NUCLEAR REGULATORY COMMISSION

Title: Advisory Committee on Reactor Safeguards
 Thermal-Hydraulic Phenomena Subcommittee
 Open Session

Date: Tuesday, December 5, 2017

Staff Preliminary Analysis of KATHY ATWS-I

OPERATING DOMAIN AND RPT

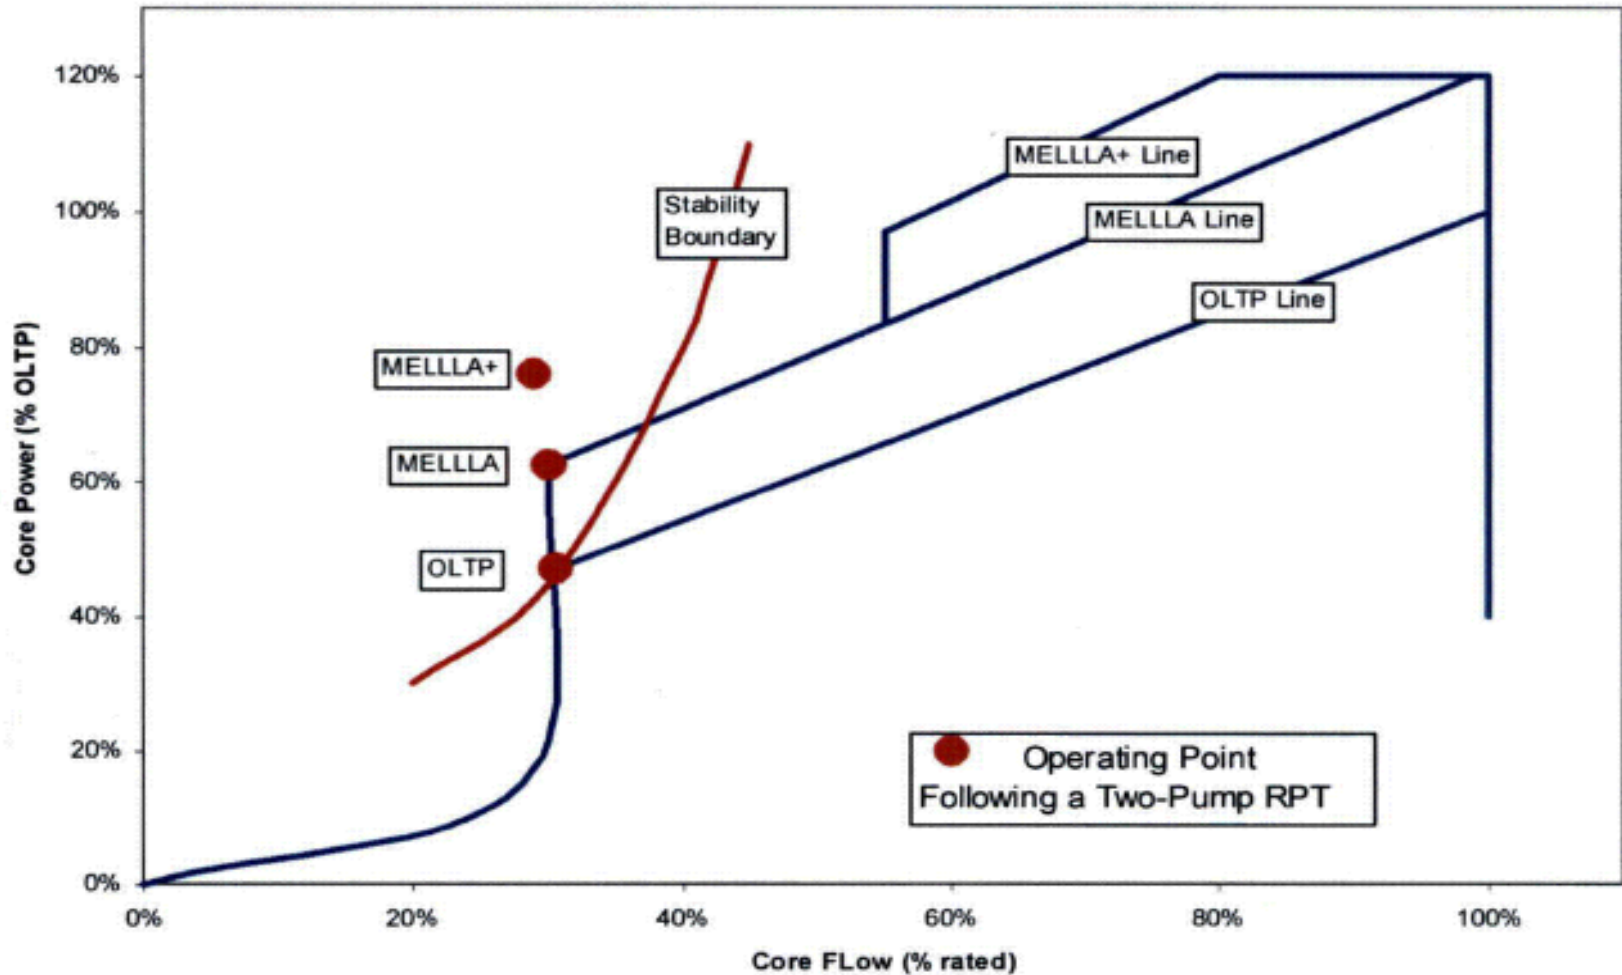
23 MEMBER CORRADINI: Just, can you go back.

24 Just to be sure, go back a slide. The OLTP is where
25 we set the --

1 MR. YARSKY: No, this power and flow map
2 that I'm showing is a little bit of a cartoon. It
3 doesn't represent any particular plant. The stability
4 boundary is set by actual -- essentially the geometry
5 of the core and the pressure losses in the core is a
6 big contributing factor to where the stability boundary
7 is. It's generally analyzed on a cycle specific basis
8 in the stability boundary moves.

10 MR. YARSKY: So it's not meant to say that
11 the blue curve representing the OLTP line is in some
12 way related to the stability boundary. This is just
13 a --

17 MR. YARSKY: So that they intersect in this
18 particular figure is more a coincidence than that it
19 would be driven by some consideration of the ATWS event.

20 CHAIRMAN MARCH-LEUBA: Since I drew the
21 figure in my previous life, the intention I had there
22 is that originally the reactor would have been stable.
23 And as we start to add modifications to it, it became
24 more and more unstable.

PEAK CLADDING TEMPERATURE RESULTS

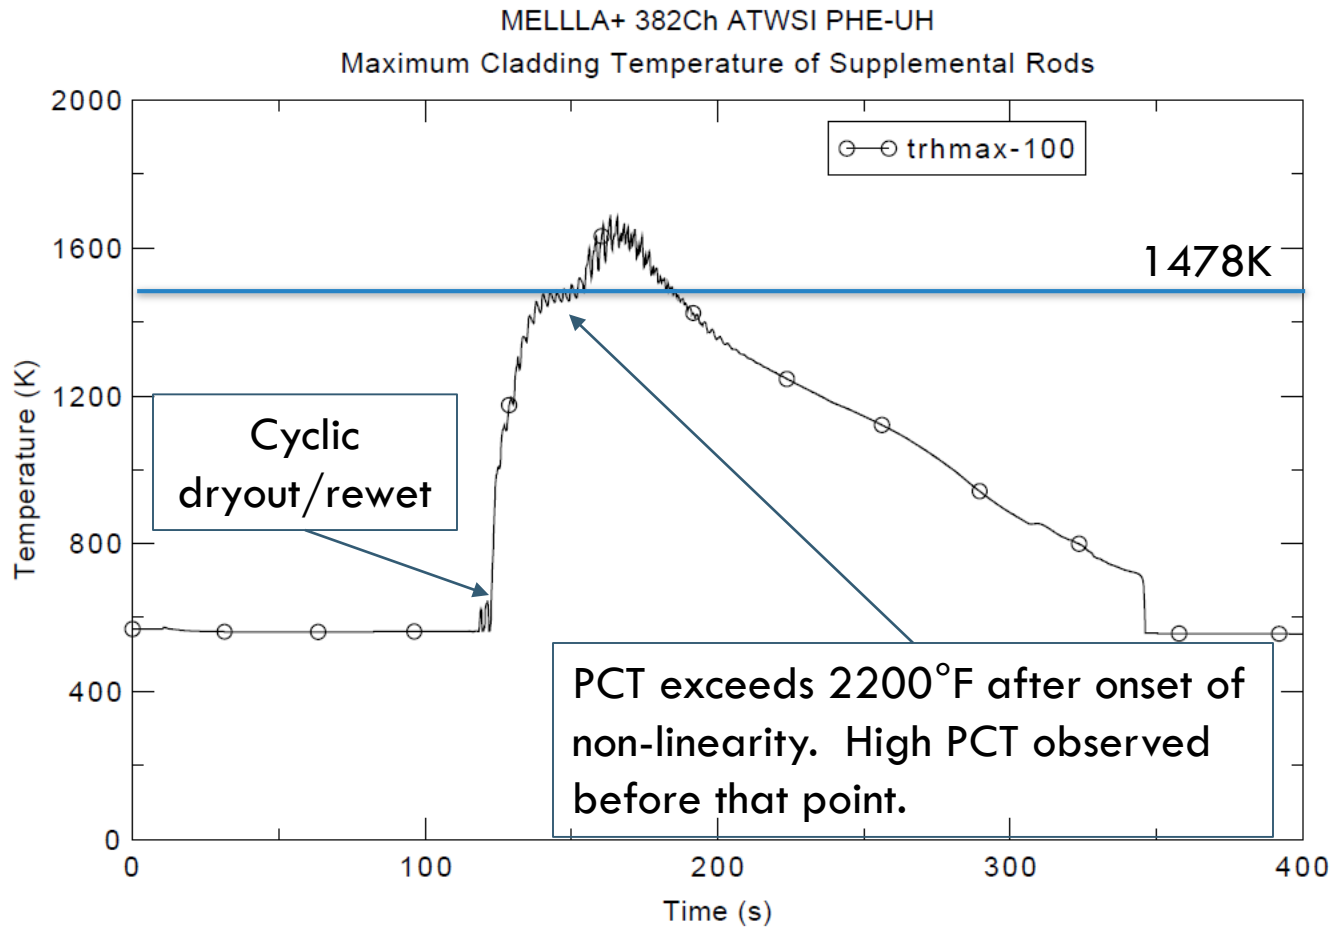
10 CHAIRMAN MARCH-LEUBA: But just two
11 things. First, you can reach the -- the point of no
12 return where you're going to failure to rewet and
13 continue to overheat and never reach 2200 because your
14 power is not high enough. And you figure if we had
15 not moved into a --

5 CHAIRMAN MARCH-LEUBA: The other thing I
6 wanted to point out on this figure is that you have
7 an oscillation in the whole band, the 10 by 10 bundle.

16 MR. YARSKY: Right. So if you return to
17 this figure, we could postulate an event where you would
18 have a failure to rewet, but still not exceed 2200.

10 MR. YARSKY: No, it's actually more subtle
11 than that. I mean, for a cartoon type understanding
12 what's going on, you could think of this figure as the
13 hot spot, but it's not. This represents that each point
14 in time the highest temperature on any cladding in the
15 core. So it's searching. So it's really happening
16 around this bump is that this point is a different point
17 now. There's a different hot spot. So this is not
18 the temperature history of a particular spot in the
19 core.

20 From the standpoint of just understanding
21 the phenomenon, you could look at this figure and think
22 of it in that way and you would have the understanding
23 necessary I think to move on. But it's a very important
24 subtle point of this figure that it is not, it's not
25 a history of an individual spot.
